**Permit #:** 61**Permit Date:** 05/02/23**Permit Type:** Planning Commission**Case Number:** PC 23-22**PC Meeting Date:** h. 1st Tuesday of October**BZA Meeting Date:****Assigned Meeting Date:** 10/03/2023**Special Meeting Date:****Applicant Is:** Contractor**Applicant Name:** ELY Mandle**Applicant Address:** PO BOX 647**Applicant City, State, ZIP:** Oxford MS 38655**Applicant Phone Number:** 731-426-3964**Applicant Email:** ely@ascentnashville.com**Description:** Proposed structurally supported parking pad constructed in the steep slope.**Project Cost:** 2000**Square Feet:** 0**Lot Area:** 0**Lot Coverage:** 0**Heat/cooled area:** 0**Proposed Height(ft.):** 0**#of stories:** 0**Lot Depth/Width Ratio:****Avg. front setback of adjacent homes:****Zoning District:** Zone C**Radnor Lake Impact Zone:** Yes**Steep Slope:** Yes**Plat/Subdivison:** No**Status:** Open**Assigned To:** Steve Mallory**Property**

## MEMORANDUM

Subject: PC Case 23-22, Radnor Lake Impact Zone and Steep Slope Site Plan for 5031 Lakeview Drive

**C1.0**  
 DEMOLITION PLAN

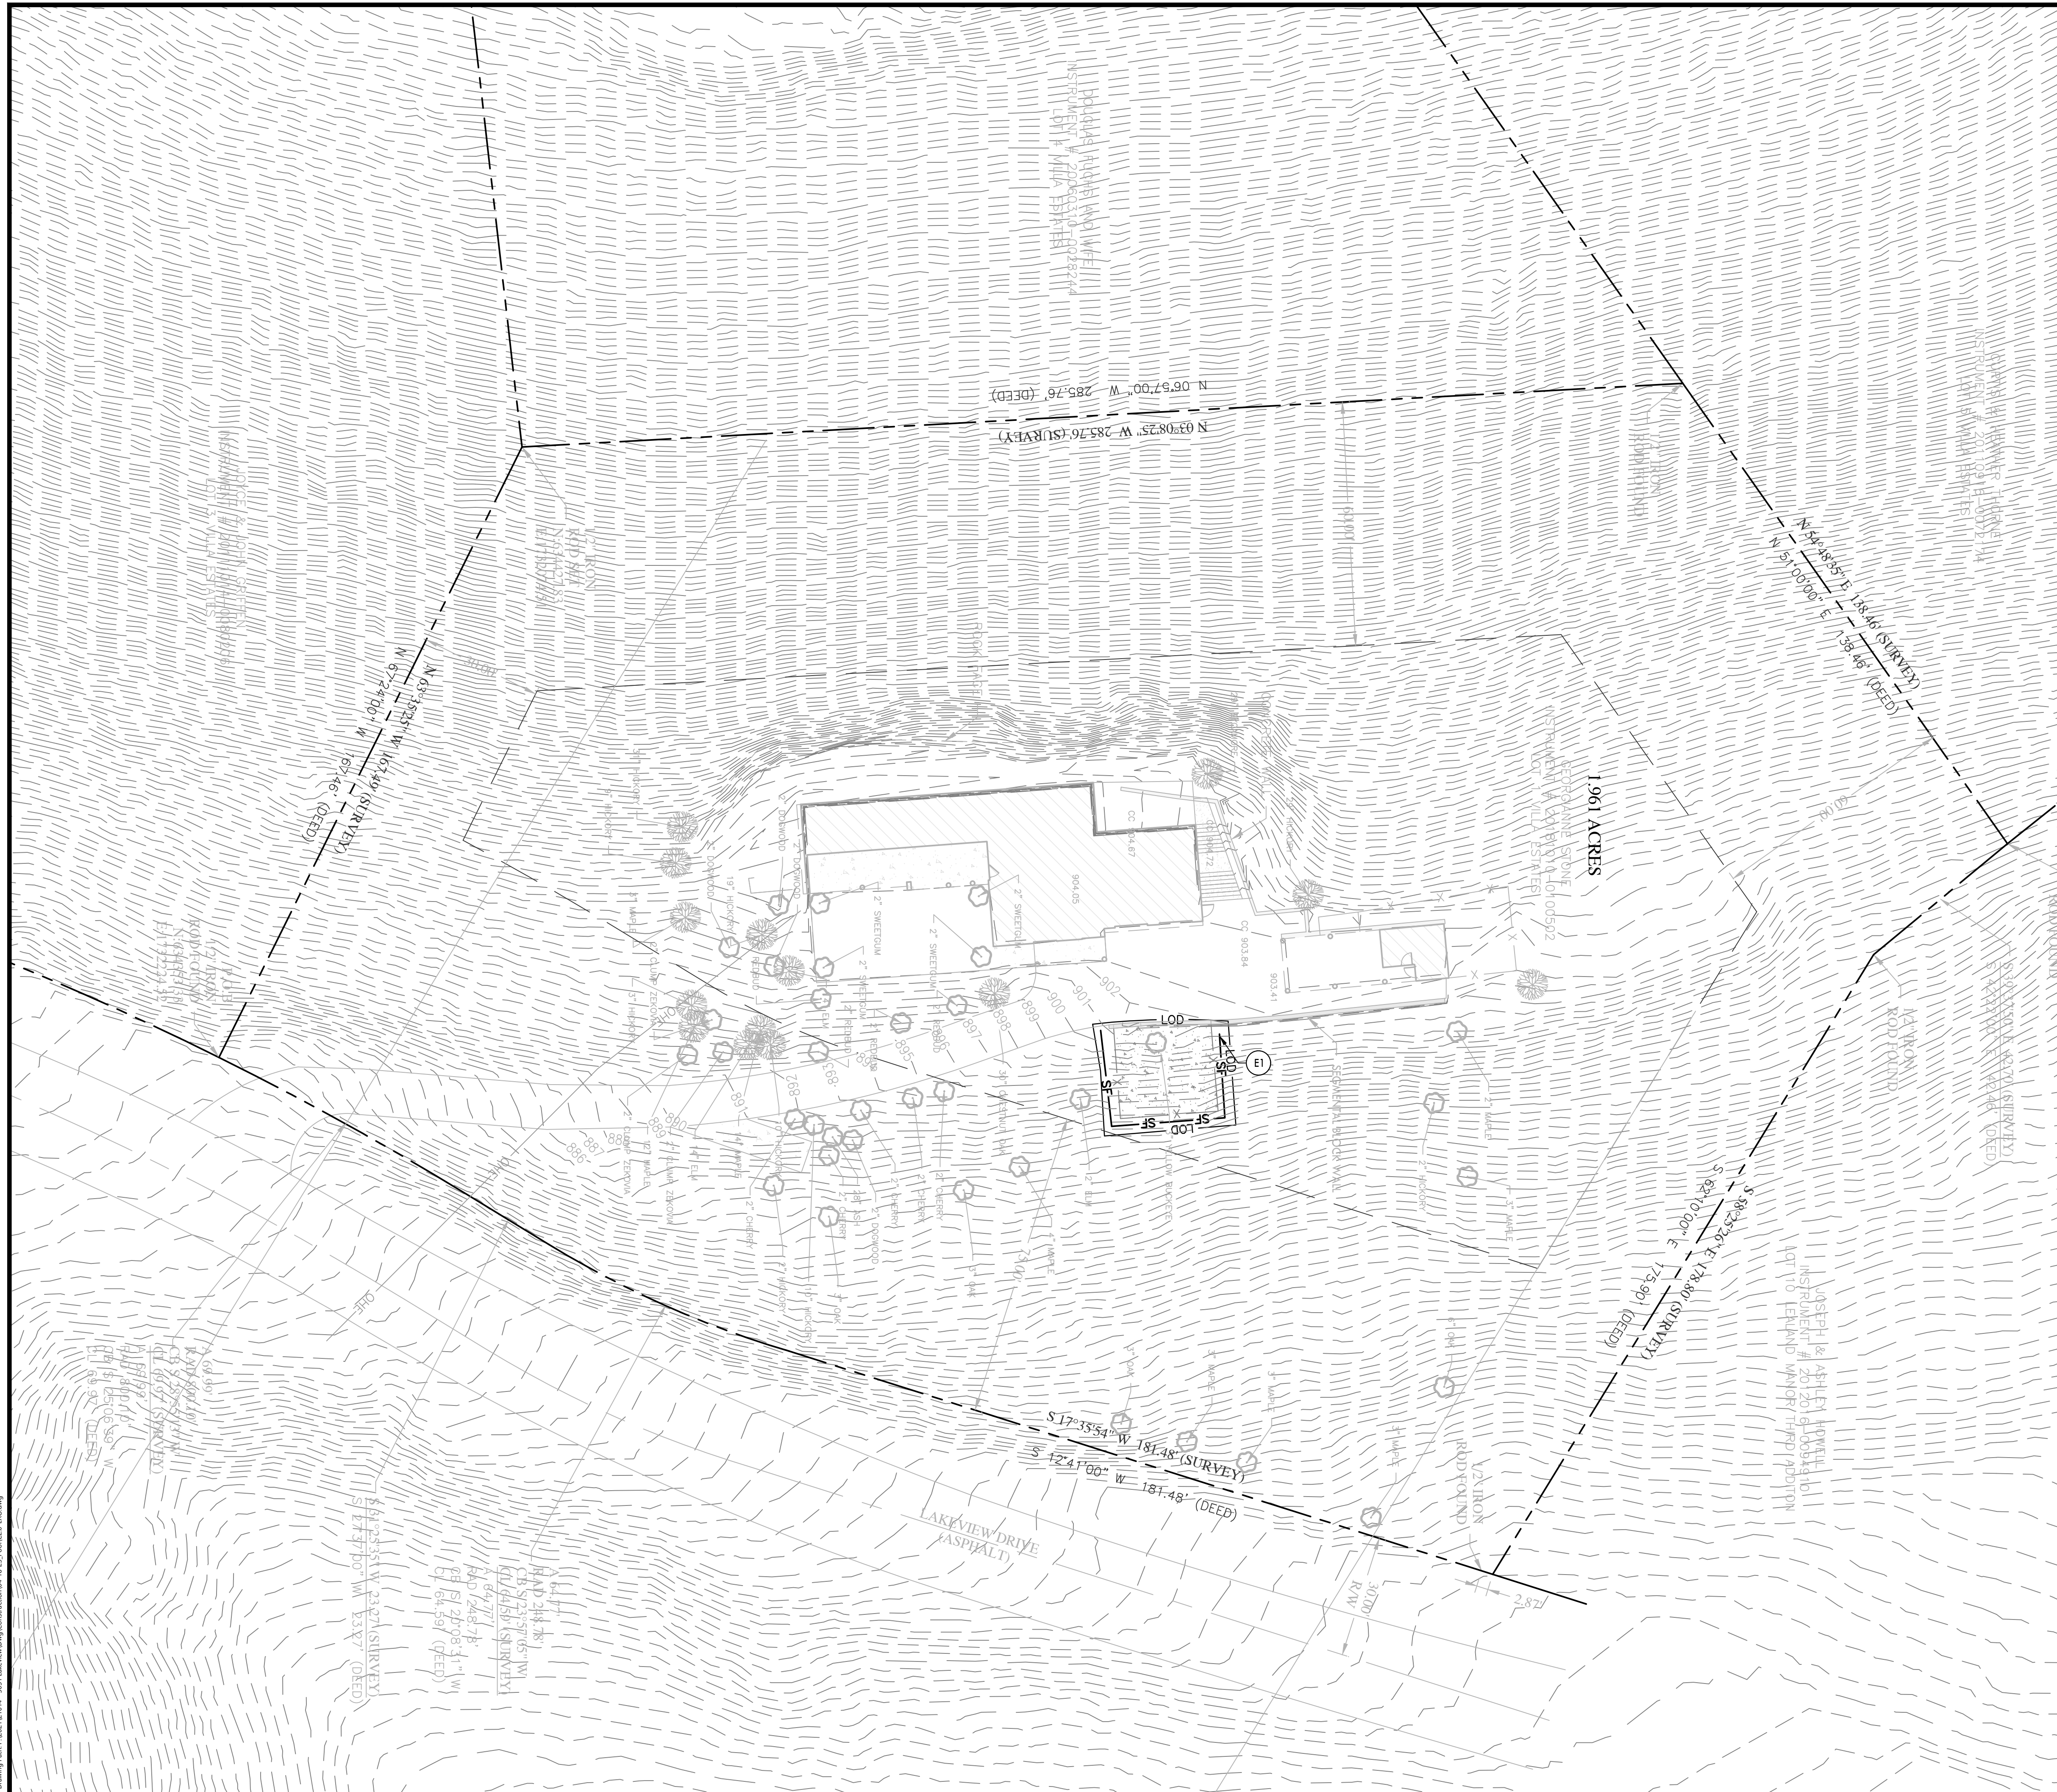
- a. Pool has been removed from the plans.
6. There is no demolition shown in the existing patio where the proposed pool is going.
  - a. Provided. Pool area demo has been removed from the plans.

**2**  
**TEMPORARY TREE PROTECTION**

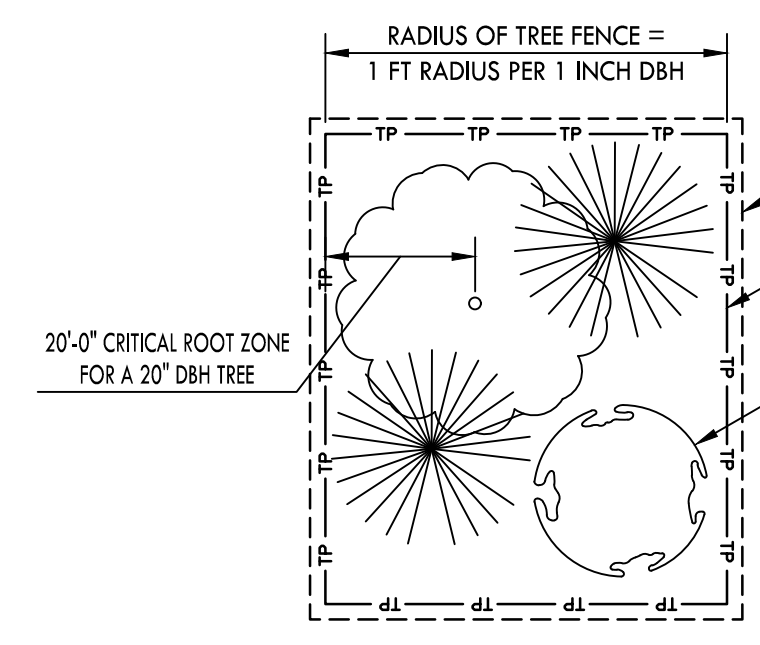
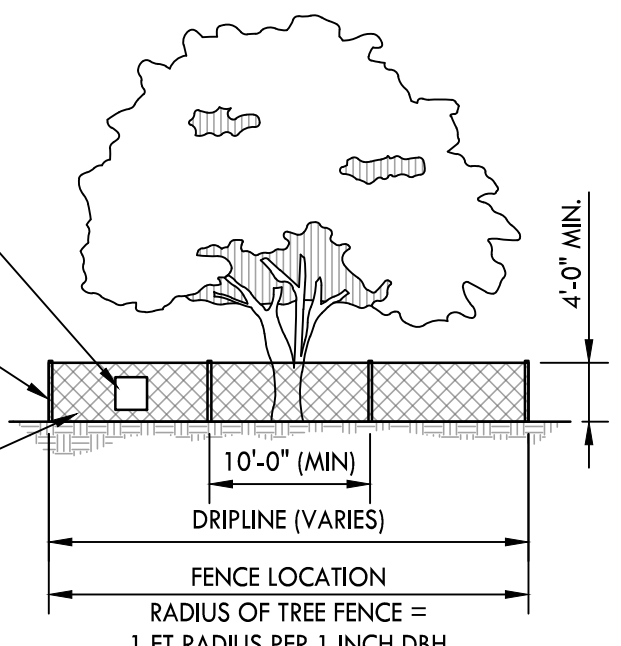
7. Show tree protection detail and tree protection lines on the plan at the drip line of existing trees that are adjacent to the construction limits.
  - a. Provided.

**C3.0**  
LAYOUT PLAN

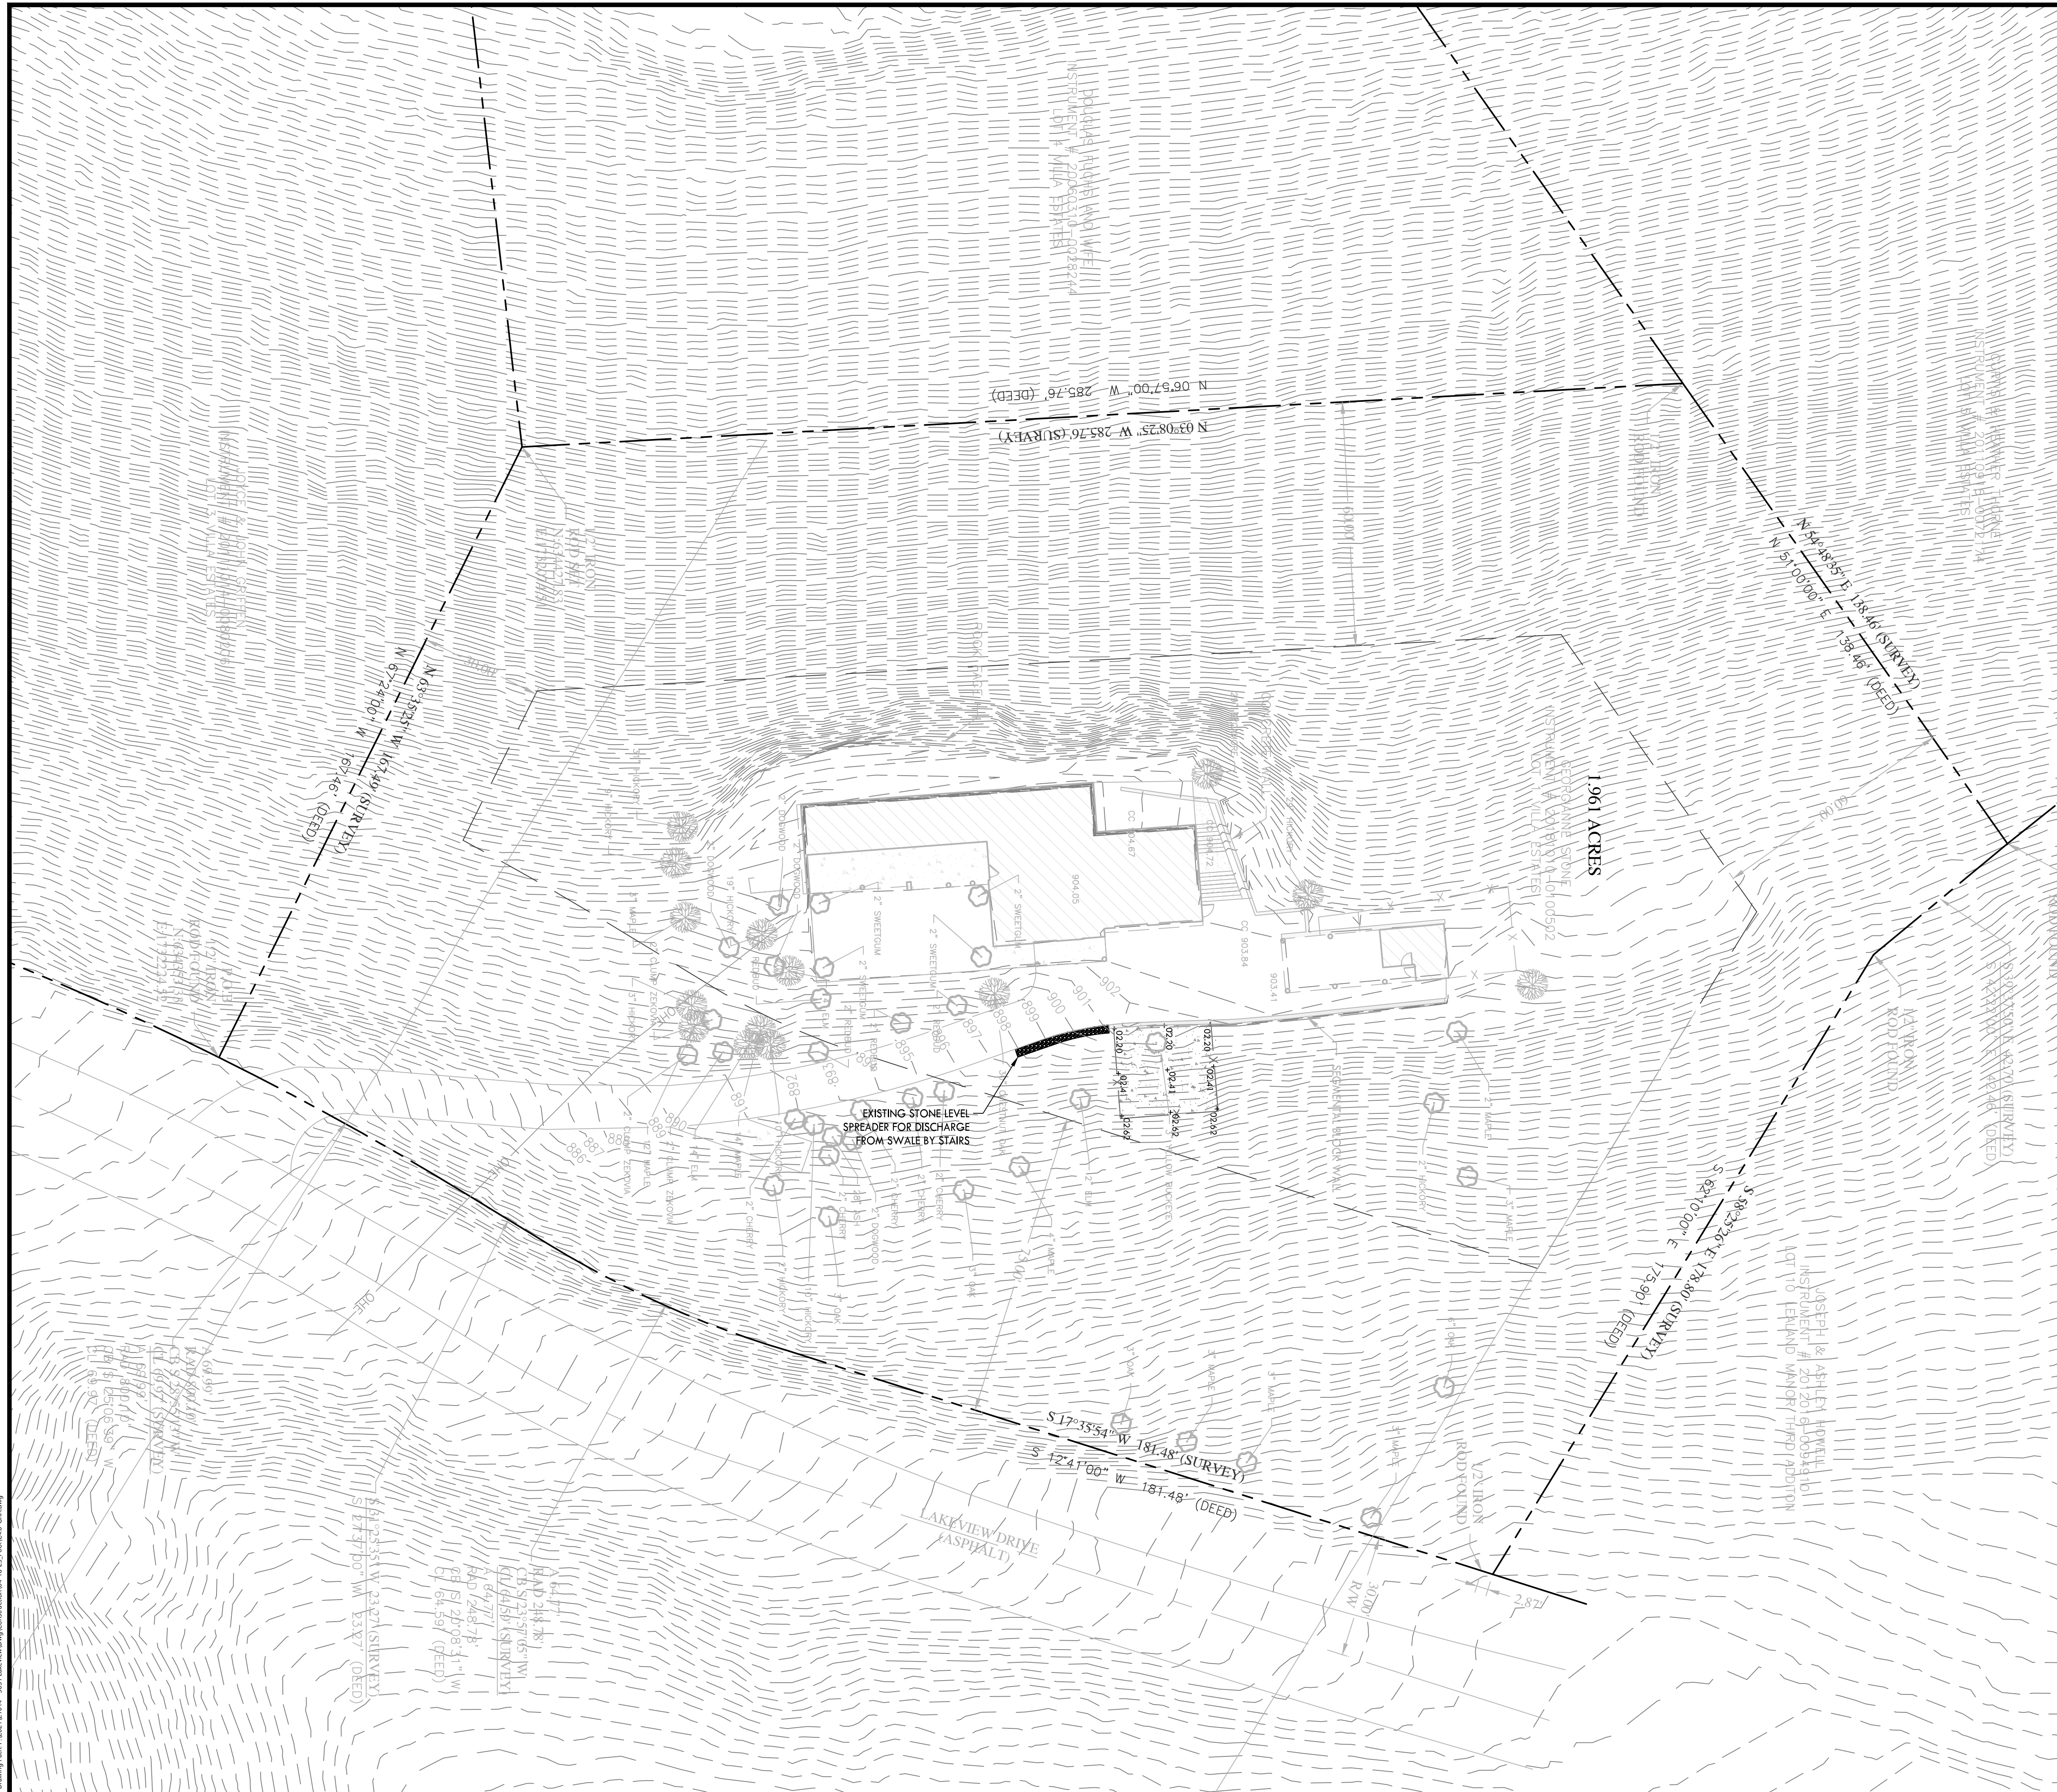
8. Show any trees that are to be removed or add a note that no trees are to be removed.
  - a. One tree is proposed to be removed as part of this project.

- b. Two new trees are proposed to mitigate the one removal.
9. Provide a stabilization plan for the areas of disturbance including any access areas – all grassed areas on steep sloped must be sodded.
